January 12, 2001

The Egyptian Civil Aviation Authority requests and authorizes you to place the Response of EgyptAir to October 31, 2000 Submission of The Boeing Company regarding the EgyptAir Flight 990 investigation into the public docket for the EgyptAir Flight 990 investigation.

Response of EgyptAir  
to  
October 31, 2000 Submission of  
The Boeing Company  
Regarding  
The EgyptAir Flight 990 Investigation

Figure 1. Elevator Response to Autopilot Disconnect on an Airworthy B-767

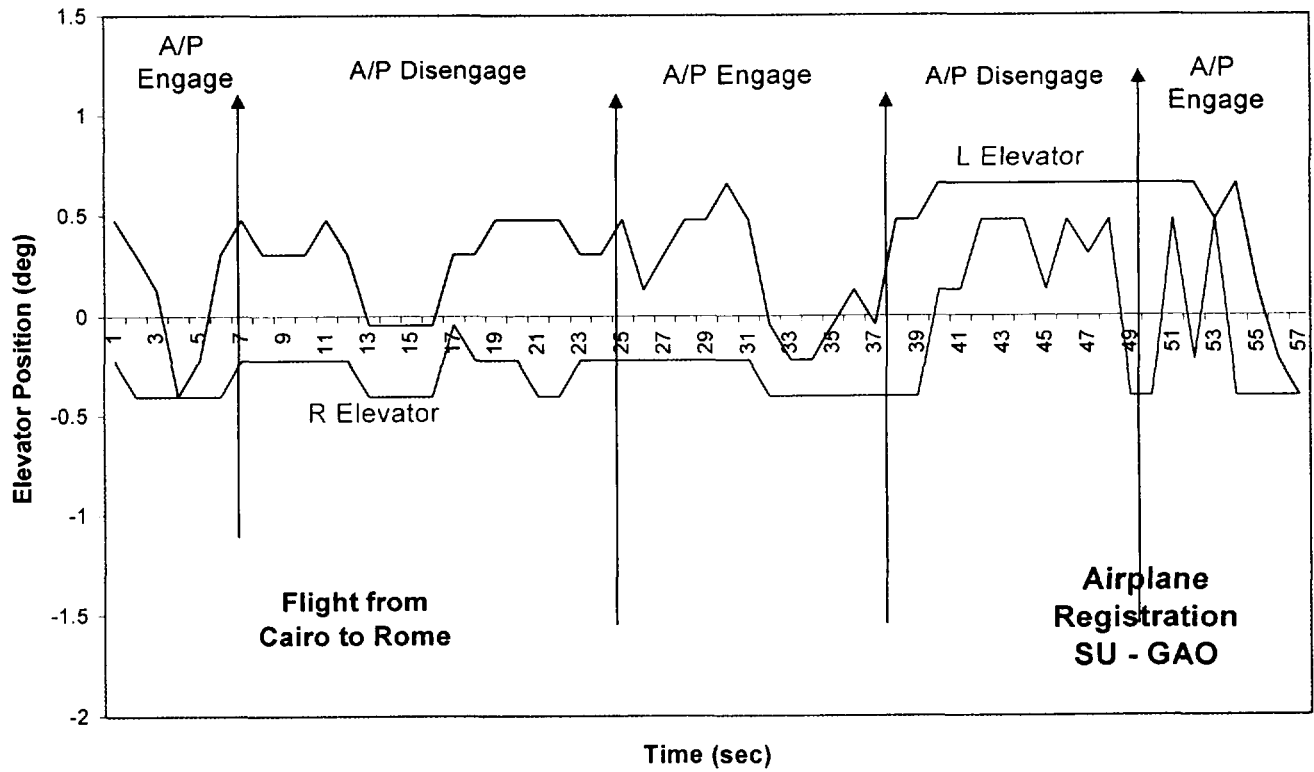
The erratic behavior of the autopilot caused Egyptian investigators to review all instances of autopilot disconnection on the 25 hour FDR recording. Of special note is that each time the autopilot was disengaged, there was an obvious downward movement of elevators, with the right elevator showing a greater deflection than the left. To analyze this data, EgyptAir test flew another 767 and performed a series of autopilot disconnects and reviewed the FDR data from those test events.

This set of test autopilot disconnects was performed during cruise on a flight from Cairo to Rome. As was expected, the data relating to these disconnects showed no marked difference between autopilot and manual operation at the moment the autopilot disconnected. See Figure 1. This is in contrast to the data for the flight 990 aircraft where there was a consistent downward deflection when the autopilot was disengaged. This analysis shows that an anomaly existed in the Flight 990 elevator system even before the aircraft left New York for Cairo on October 31, 1999 -- a latent defect that could not be detected by the crew.

Figure 4. Elevator Deflection from Ground Test A and Analytical Model  
 Single PCA Control Valve Jam on the Right Elevator, 770 psi Feel Pressure, Pilot  
 Control Sweep

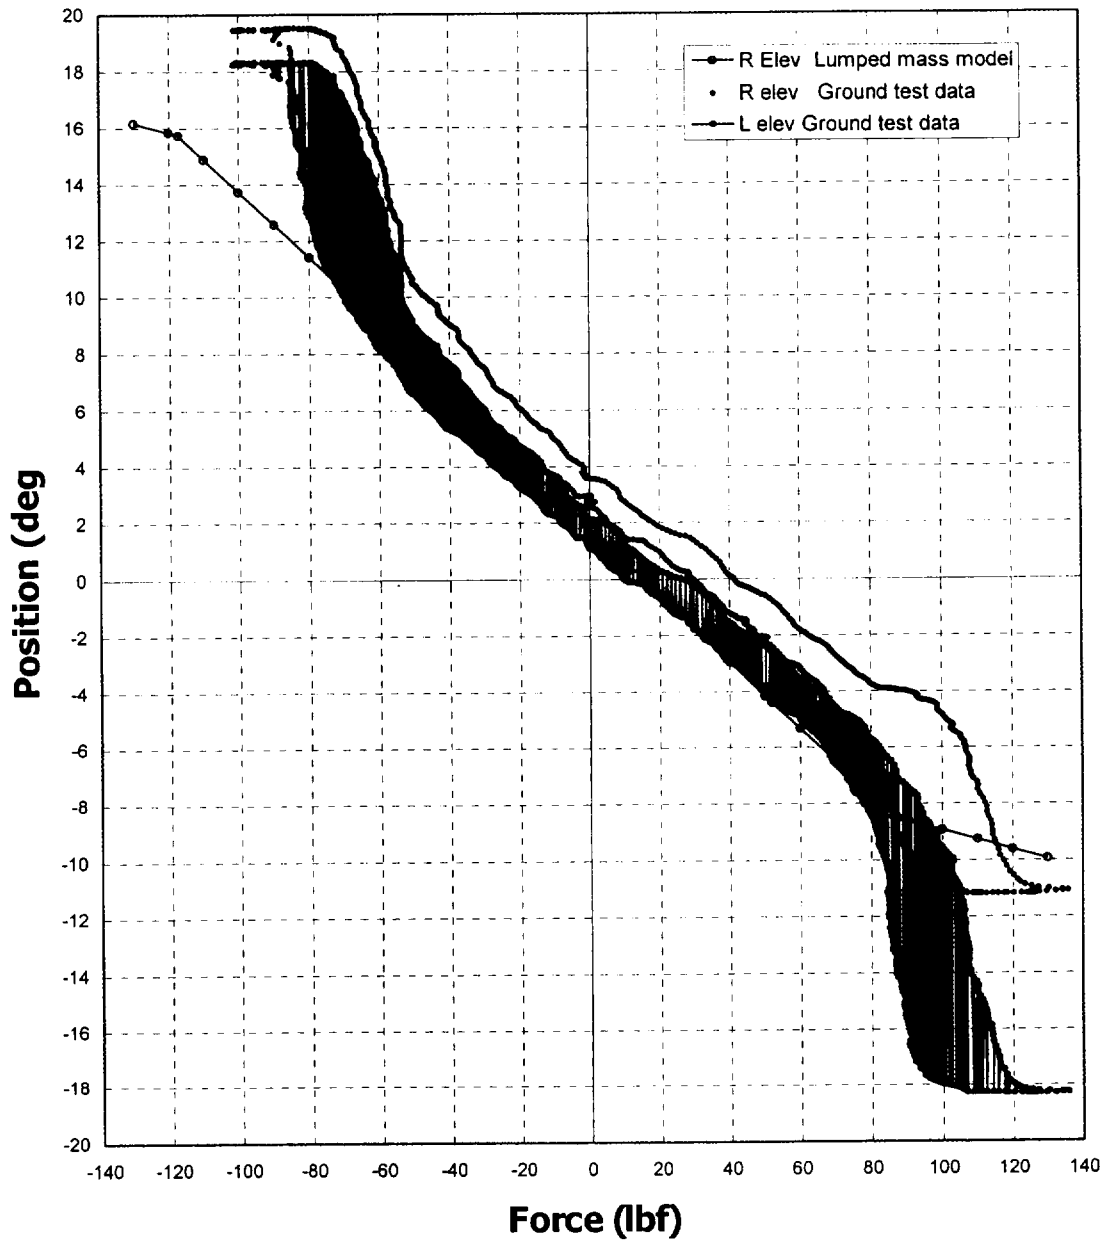
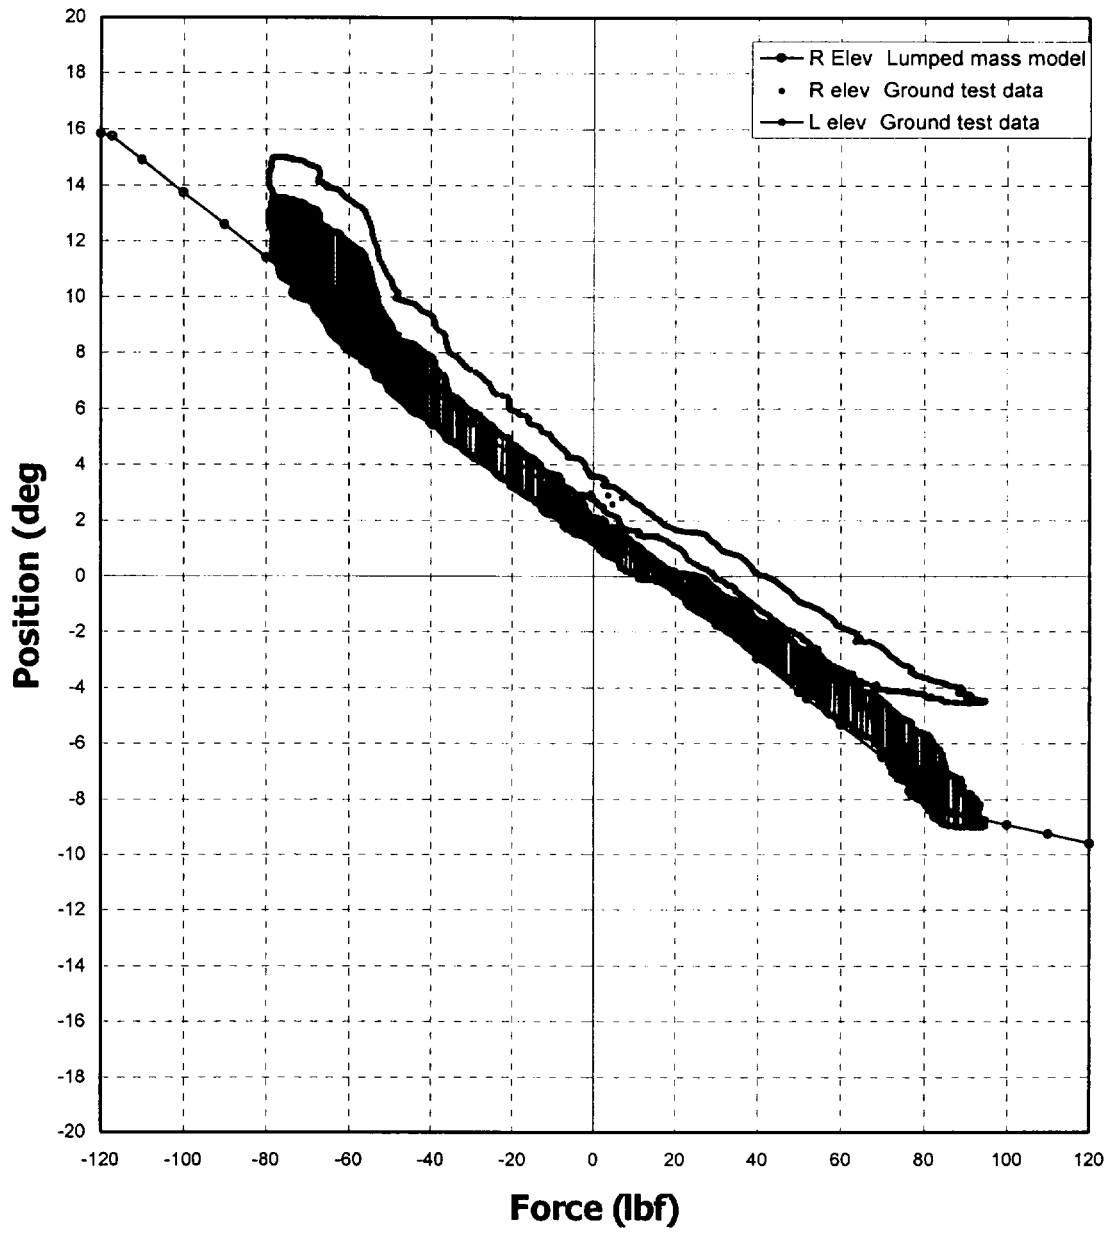
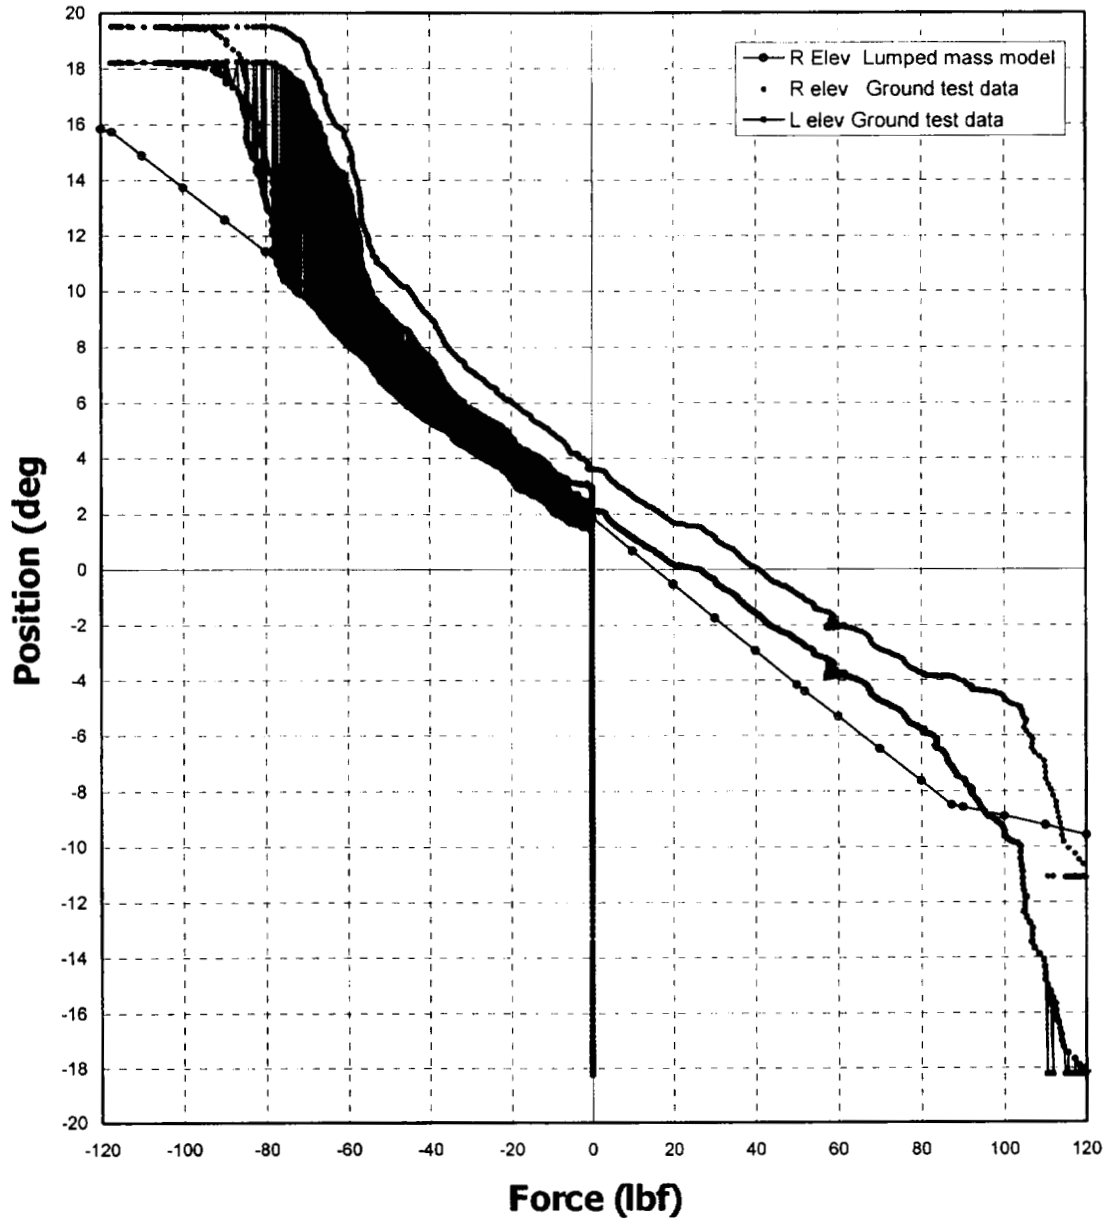
Figures 4, 5, and 6, which are extracted from the ground test data, indicate the elevator movement at a no-load condition as a result of a single PCA valve jam in the TED direction.<sup>2</sup> These figures show the results of three separate tests under the same test conditions –single PCA jam, 770 psi feel pressure, and pilot column sweep. They indicate that the right elevator is always leading the left elevator and are not consistent with the mathematical model included in Boeing report B-H200-17068-ASI-R2 -Split Elevator Failure Scenario, dated September 29, 2000 and Boeing report B-H200-17026-ASI, -767 Elevator System Operation with Regard to Column Splits, Aft Quadrant Splits, and Column Jams, dated August 2, 2000.

Figure 7. Expected Elevator Deflection as a Result of Dual PCA Valve Jam Failure (Produced by the NTSB Performance Group Chairman)

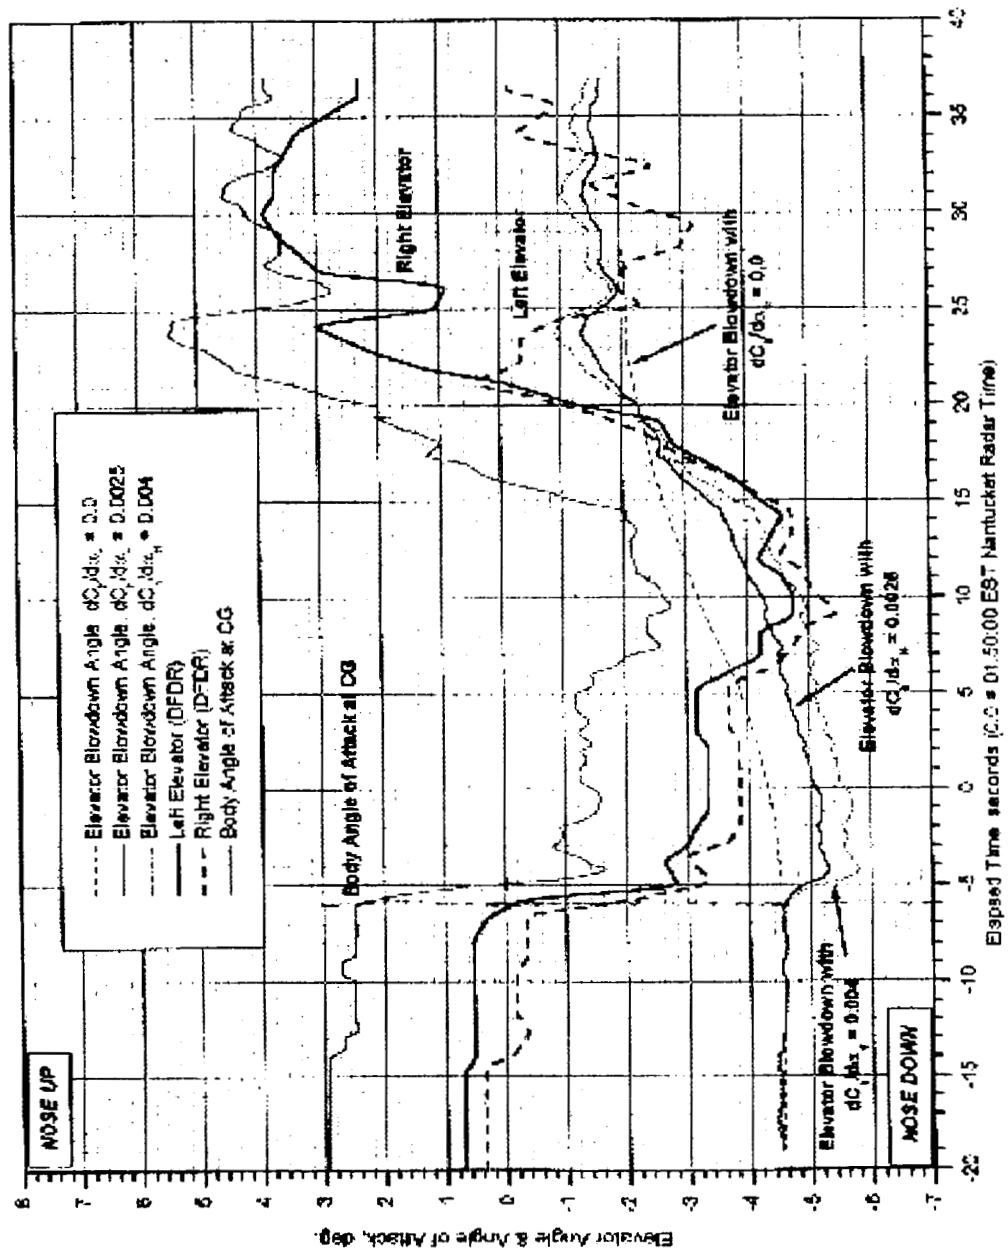
Figure 7 shows the expected elevator deflection as a result of a dual PCA control valve jam using the Boeing hinge moment data with and without considering the effect of airplane body angle variation and the FDR elevator data. These expected deflections were derived by the NTSB performance group chairman and validated by the Egyptian Delegation. From elapsed time of 7 seconds, the calculated right elevator position is within 1 degree of the FDR.<sup>3</sup>

<sup>3</sup> Figure 7 is from the NTSB and does not account for any differences caused by the rate at which the failure occurred. In addition, the labels for right and left elevator are reversed.

Figure 8. FDR Elevator and Aileron Deflection and Derive Mach Number

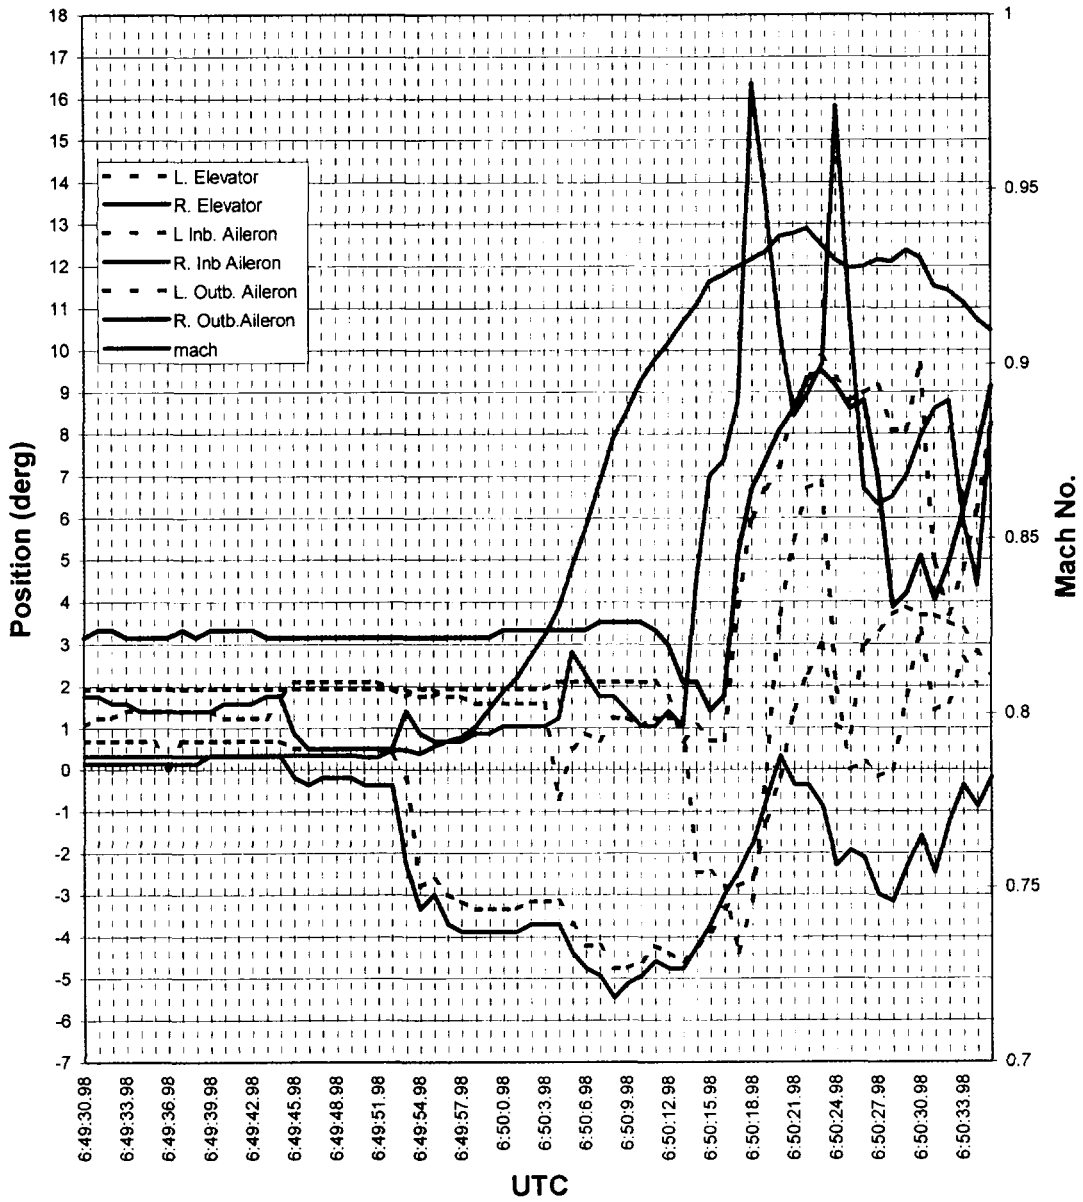
FDR data for aileron deflection is shown in Figure 8. At this time step, the differential aileron deflection was 6.5 degrees, significantly smaller than the above 26 degrees predicted by the split elevator analysis but very close to 4.4 degrees predicted by the streamlined right elevator analysis.

Figure 9. FDR Roll Angle and Derived Body Angle of Attack

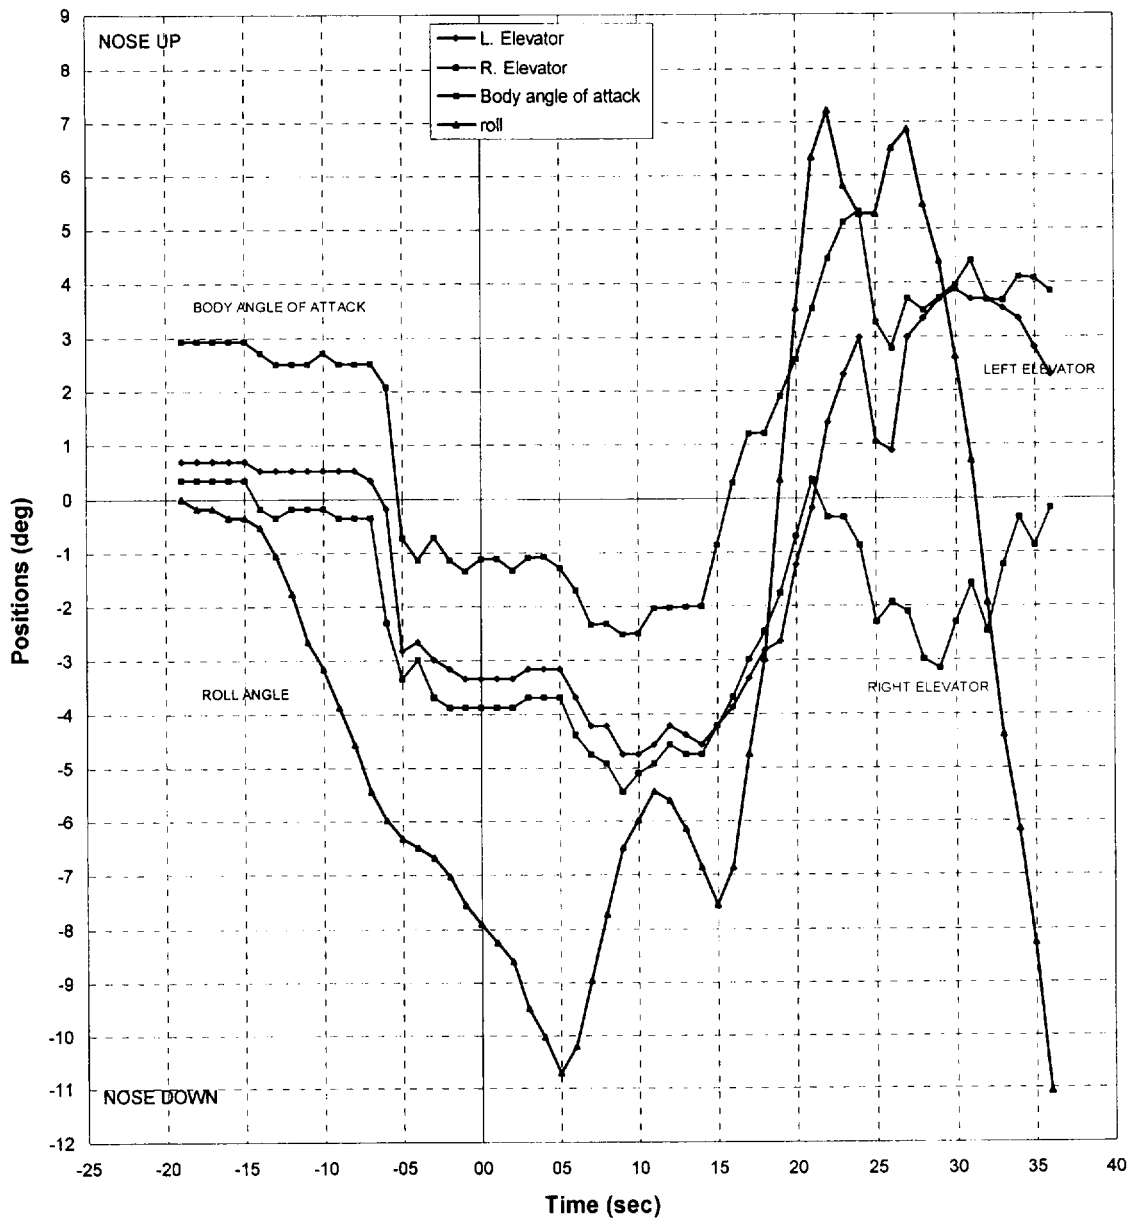
If the elevators have a differential deflection as shown by the FDR data in Figure 9, they will produce unequal lift on the left and right sides of the tailplane resulting in an aircraft rolling moment. The methods of Roskam (Airplane Design, Part VI, Roskam Aviation and Engineering Corporation) were used to estimate the lift on the horizontal tail. Basic lift for the left and right tailplane was calculated using the angle of attack as recorded by the FDR in Figure 9. The elevator was treated as a plain flap and the incremental lift on the left and right surfaces was calculated. These lifting forces were then multiplied by a moment arm assumed to be acting at one-third the elevator half span. This resulted in a net rolling moment due to the differential deflection of the elevators. One time slice 1:50:28 ET( time = 28 seconds on the x-axis), was chosen to make these calculations. The relevant parameters are listed below:

The rolling moment coefficient for the inboard ailerons was then estimated. The outboard ailerons were assumed to be locked out at this high airspeed. Figure 9 demonstrates that the roll angle was small during this time period. The aircraft was well controlled in the roll axis; therefore, the rolling moment due to elevator would be balanced by the rolling moment from the ailerons. Equating the rolling moment due to differential elevator deflection with the restoring rolling moment due to ailerons, a differential aileron deflection was calculated. The result is

Figure 10. Pitchover Simulation, Right Elevator as Recorded on the FDR

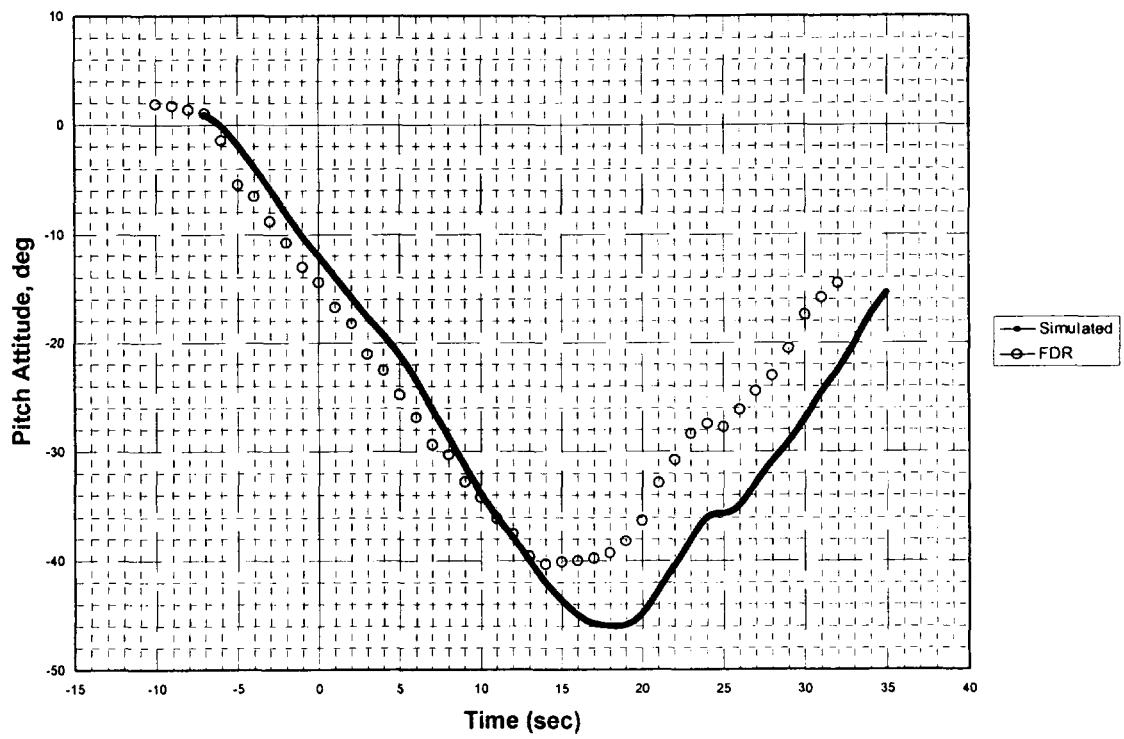
7 seconds) was performed. Models for lift, drag, and pitching moment were derived using the methods of Roskam. Inputs for elevator deflection and stabilizer incidence were taken from the FDR data. A full six-degree of freedom simulation was performed assuming that all lateral directional forces and moments were zero. The resulting pitch angle history is shown in Figure 10. With the elevator set as recorded on the FDR, the simulation continues to pitch down an additional 6 degrees beyond that recorded by the FDR. These results are due to the nose down pitching moment produced by the right elevator.
